**SOUTH CAMBRIDGESHIRE DISTRICT COUNCIL**

**REPORT TO:** Planning Committee

**C/6/9/1A**

**Discharge of Conditions - Cambridgeshire Guided Busway  
Design and External Appearance of Arbury Park North Bus Stop and of Pedestrian  
Routes at the Proposed Guideway Intersection at Arbury Park**

CGB.DES.81250-D-1-1010 | 1

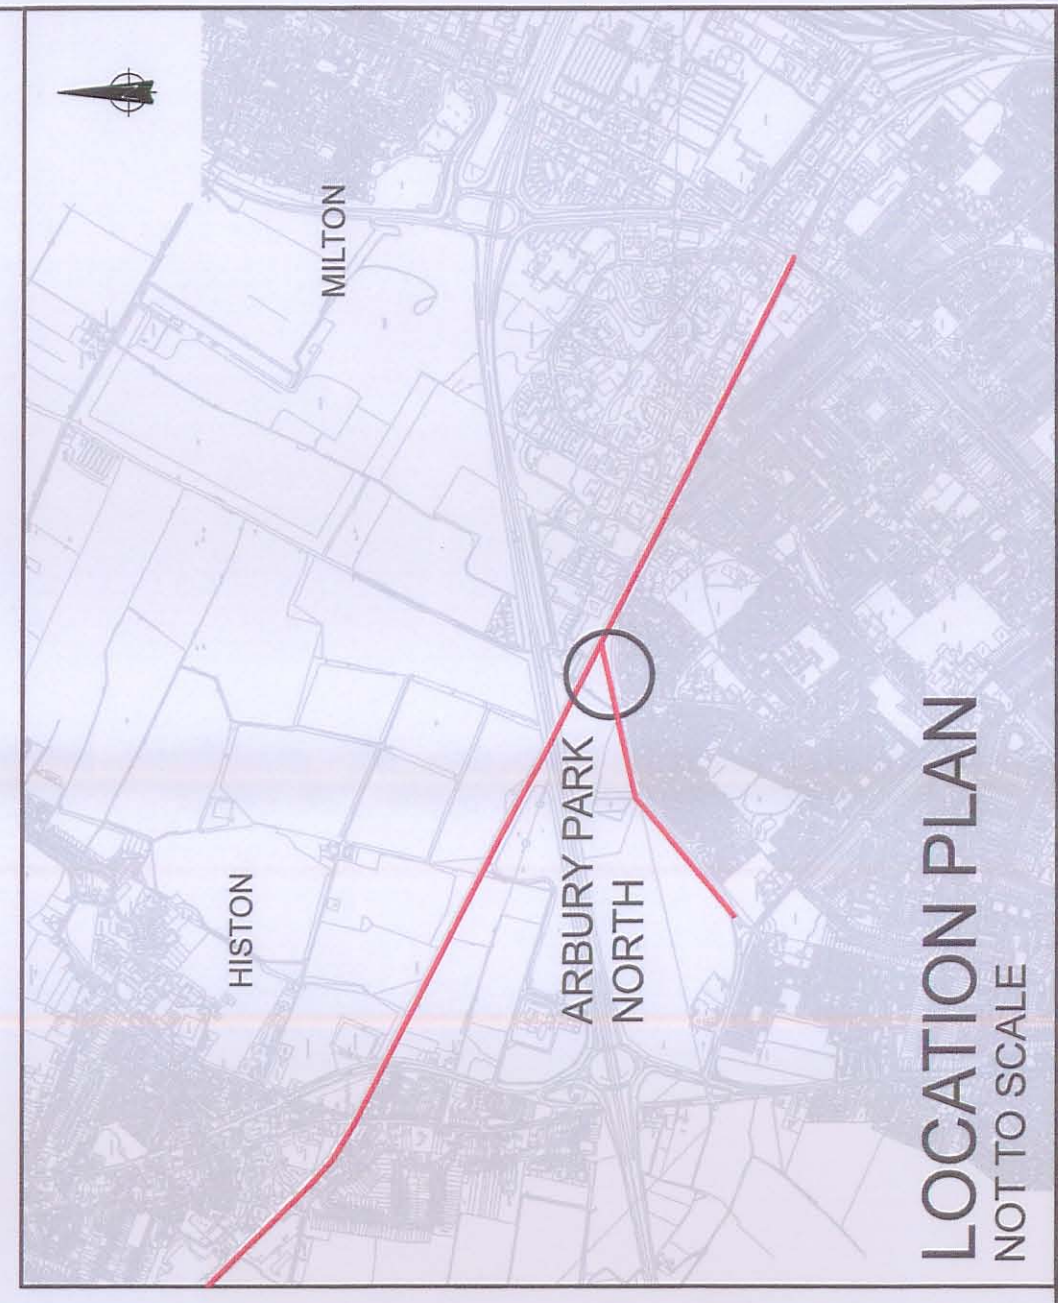
“The bus stop should be on the northwest corner of the junction to ensure Arbury Park residents are able to get a Guided Bus going through and down Milton Road and recommend refusal unless it can be confirmed that Arbury Park residents will be able to travel down Milton Road.”

“The positioning of the bus stop preventing service east from Arbury Park to the eastern section of the Guided Busway and service remains a concern and disappointment at a missed opportunity to encourage less car use.”

“I am concerned about the suitability of Rosa Canina as it is rather lanky when grown solo and could send out long arching, thorny sprays. However, if it is intended that they should be pruned occasionally they would be acceptable. Presumably visibility will be an issue at the junction of the two guideway tracks and so I wonder whether the shrubs should be omitted and instead single clear stemmed trees used, which can be crown lifted over the track if necessary, retaining visibility at eye level. Areas of long wild flower rich grass with closely mown edges could be used to direct people on to the paths.”

10. The bus stop layout and locations are in accordance with the scheme details presented at public inquiry and are, therefore, in accordance with the requirements of the planning permission for the scheme.
11. It is not possible to move the stop to land outside the control of the County Council. Secondly, a move would be contrary to the existing deemed planning permission and Transport and Works Act Order. The County has no powers to acquire land outside the scheme. In any event land to the north of the guideway junction is already required for the Arbury development itself on one side, and on the other an Ecological Mitigation area.

17. Notwithstanding the fact that the condition only requires approval of design and external appearance, there is insufficient land to the north west of the guideway junction to provide a bus stop. On the south side of the guideway development of Parcels J1 and J2 is nearing completion. J2 largely comprises a 3 storey block of flats. A re-routed ditch to the north of the building would be approximately 4m from the guideway. On the north side is an approved Landscape and Ecology Mitigation (LEM) Area M, which comprises a 0.35 hectare triangular piece of land between the guideway and the A14 Trunk Road.

18. I have no objections to the design and external appearance of the bus stop.

19. Subject to the comments of the Landscape Design Officer being taken into account, it is recommended that Condition 3(a)(i) be discharged in regard to the design and external appearance of the Arbury Park North Bus Stop.

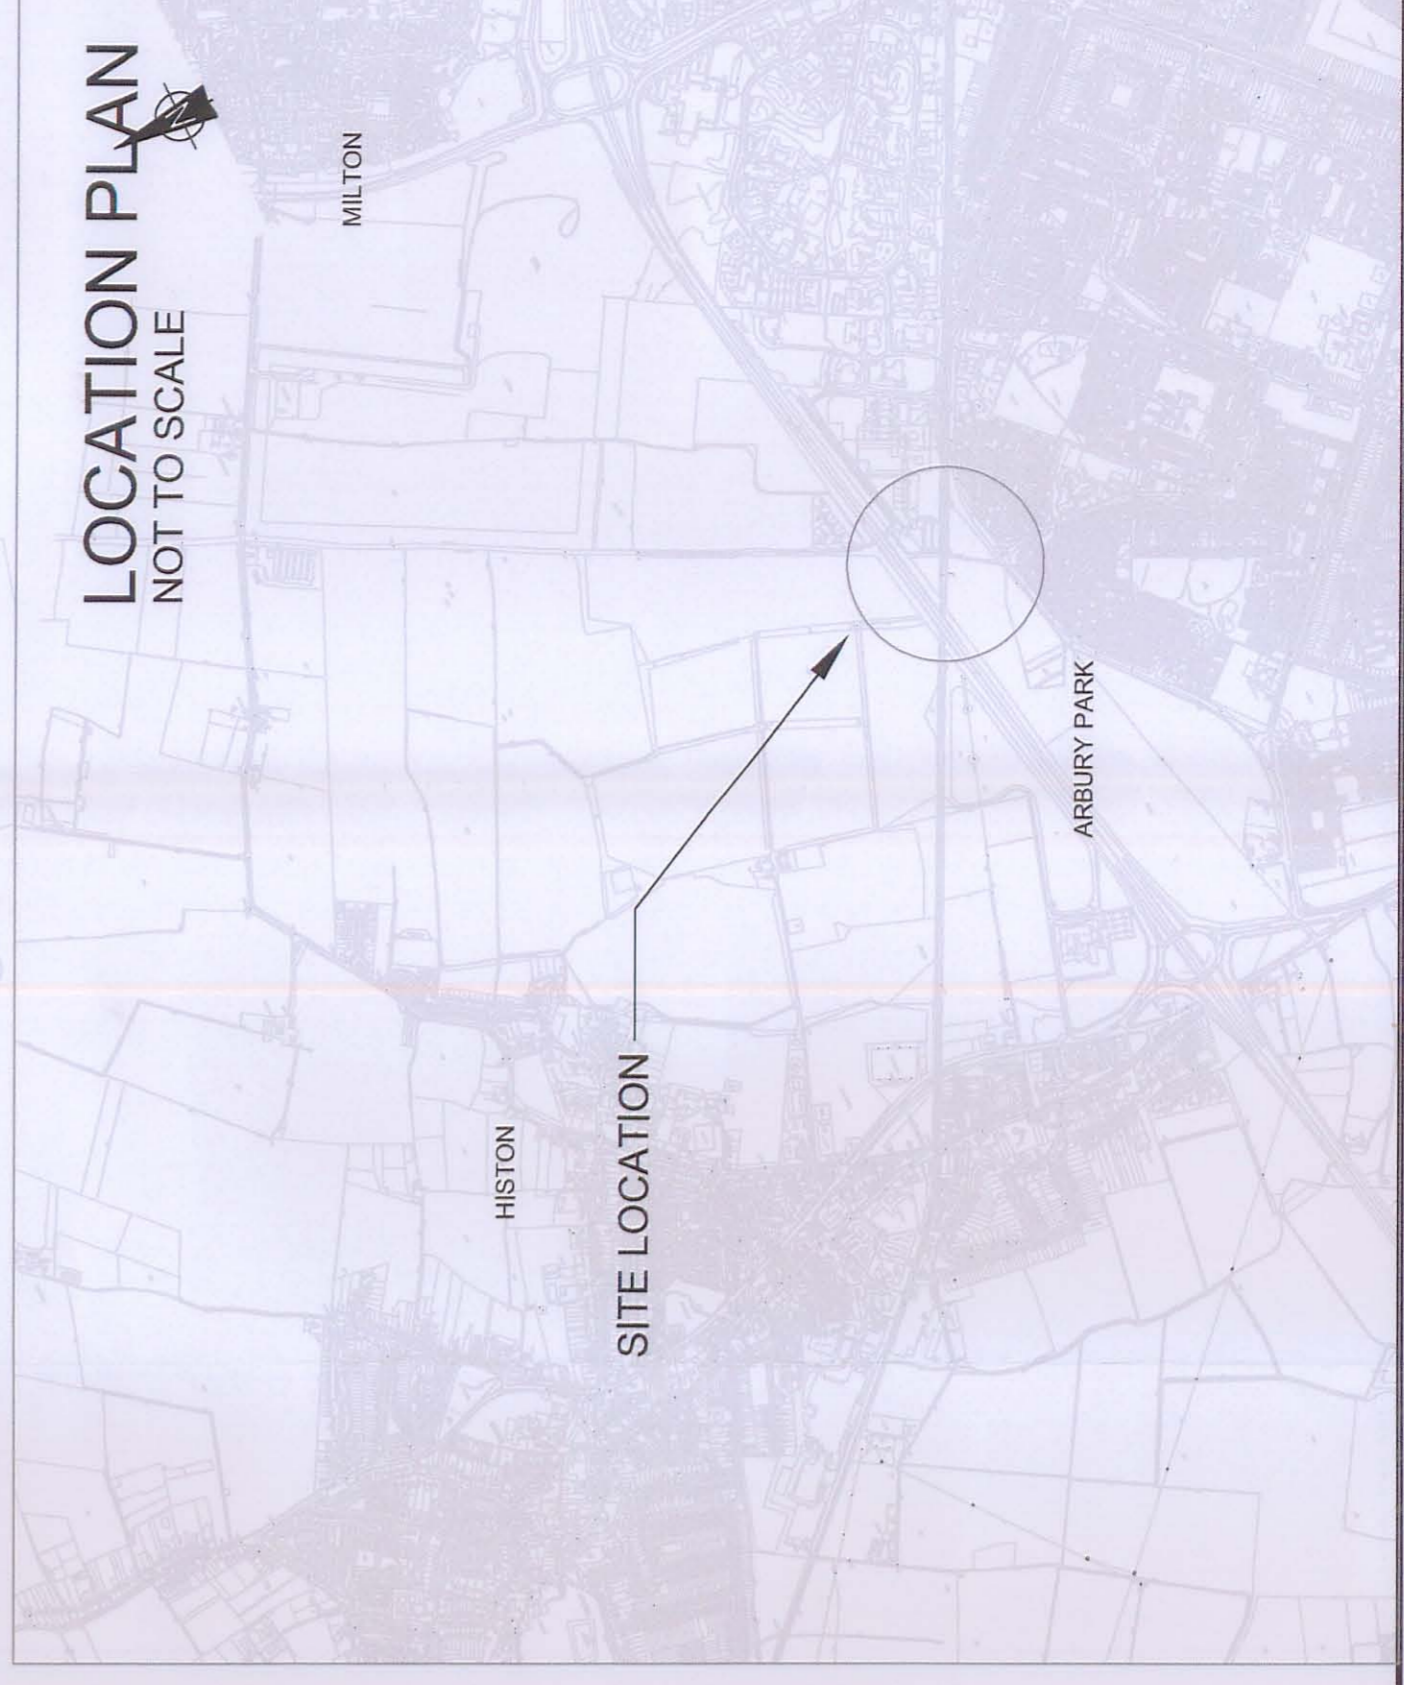
21. **Impington Parish Council** recommends refusal as "public consultations had indicated maintenance track would be tarmacked and suitable for cycles. Plans now say unbound material".
22. The **Local Highways Authority** has no objections.

"I suggest that the corners of the junctions of footpaths and the maintenance track are rounded off where people movements involve changes of direction. Inevitably they will cut the corners and wear muddy patches in these places. The path from the maintenance track leading to the crossing adjacent and north of the west platform should probably be divided into two paths recognising the separate desire lines. One should lead towards the access to the adjacent housing and the other to the crossing over the main guideway so that a triangle is formed with the maintenance track. Cyclists will be using this route and they always cut corners. The triangle could be grassed and the adjacent planting moved slightly to accommodate the paths.

I see that the landscape plan for the adjacent housing at Arbury Park shows a hedge against the north west boundary of the guided bus land, and the housing lies very close behind this. I would prefer therefore to see the footway pulled back towards the kerb to match that on the opposite side of the busway. This would leave a more satisfactory rooting area for the trees and shrubs and allow the light to be pulled further away from the dwellings. A more generous buffer of vegetation will be possible on this corner and pedestrians will feel safer at night, not having to walk between a hedge and groups of shrubs and trees.

I should still like to see the design chosen for the lights. Is it really necessary to have 8m columns at the bus stops where they are closer together? Assuming that the appropriate lighting levels would be achieved, coming down to a shorter column here would create a more pedestrian-friendly feel."

25. The applicant has accepted that the drawing is incorrect in regard to the surface material of the maintenance track. It should read "bituminous" as annotated on the Bus Stop drawing. Equally the pedestrian/cycle paths at the junction will be bituminous, 3m wide and will have uncontrolled crossings of the guideway and Arbury Link. The junction will be lit.
26. The proposed footpath on the south west side of the junction will be close to the proposed boundary planting on the Land Parcel J2. The plans contain no indication of finished levels. The applicant on Parcel J2 wishes to amend the boundary treatment but it is difficult to agree details in the absence of known finished levels. In view of comments from the Landscape Design Officer, I shall discuss further the detailed alignment of these paths.

27. Subject to reconciling levels with boundary treatment on Land Parcel J2 and agreeing the exact alignment of the paths, it is recommended that Condition 3(a)(iv) be discharged in regard to design and external appearance of pedestrian routes at the proposed Guideway Intersection at Arbury Park.
